Draft Change Proposal – BSCP40/01

DCP No: 0030

Version No: 2.0
(mandatory by BSCCo)

Improving Microgeneration Processes in the Code Subsidiary Documents.

Figure 1 (above): illustrates the model as proposed by option 1.

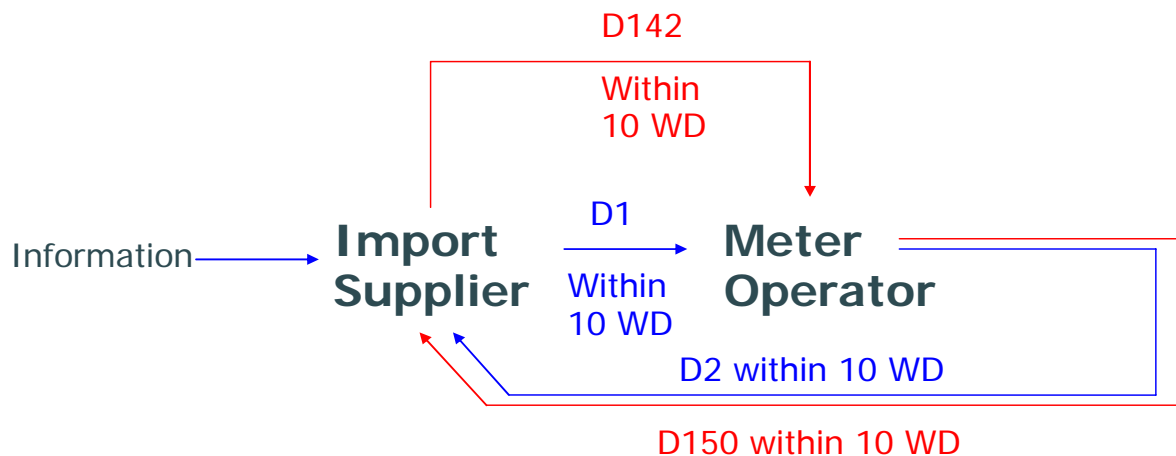
- (a) On becoming aware that microgeneration equipment is being installed, the Import Supplier sends a D0001 flow to the Meter Operator to investigate/confirm whether the relevant Meter requires a backstop within 10 Working Days.

- (b) The Meter Operator responds to the Supplier with a D0002 ‘Fault Resolution Report or Request for Decision on Further Action’ flow outlining whether the Meter has a backstop within 10 Working Days.

- (c) If the Meter does not have a backstop, the Supplier sends the Meter Operator a D0142 ‘Request for Installation or Change to a Metering System Functionality or the Removal of All Meters flow’ requesting the Meter Operator to replace the Meter within 10 Working Days. If the Meter does have a backstop then the Supplier does not take any further action.

- (d) When the Meter has been replaced the Meter Operator sends a D0150 to the Supplier to confirm that the Meter has been replaced.

Figure 2 (above): illustrates the model as suggested option 2.

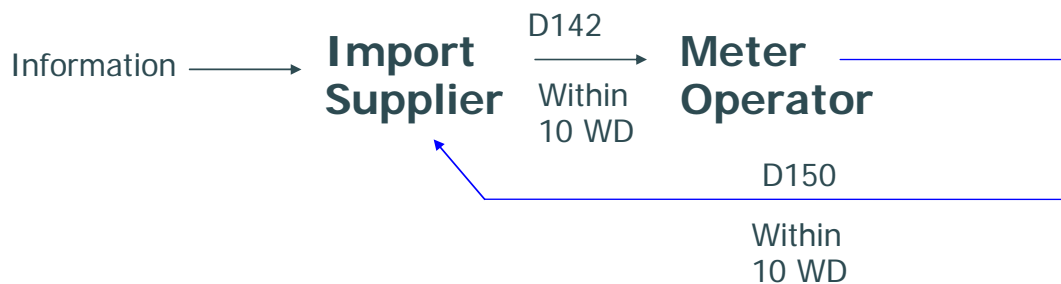
- (a) On becoming aware that microgeneration equipment is being installed, the Import Supplier sends a D0142 flow to the Meter Operator to investigate/confirm whether the relevant Meter requires a backstop within 10 Working Days.
- (b) The Meter Operator subsequently responds to the Supplier with a D0150 ‘Non Half-hourly Meter Technical Details’ flow outlining whether the Meter has a backstop or indicating that the Meter has been replaced, within 10 Working Days.

Figure 3(above): illustrates the model as proposed by option 3.

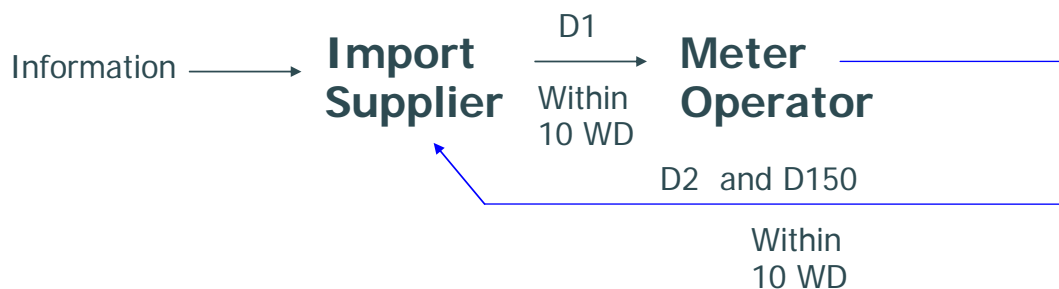
- (a) On becoming aware that microgeneration equipment is being installed, the Import Supplier sends a D0001 flow to the Meter Operator to investigate/confirm whether the relevant Meter requires a backstop within 10 Working Days.
- (b) The Meter Operator subsequently investigates whether the Meter requires a backstop and where appropriate replaces the Meter with one that is fitted with a backstop. The Meter Operator subsequently responds to the Import Supplier with a D0002 and D0150 at the same time, outlining whether the Meter has a backstop and whether the Meter has been replaced, within 10 Working Days.
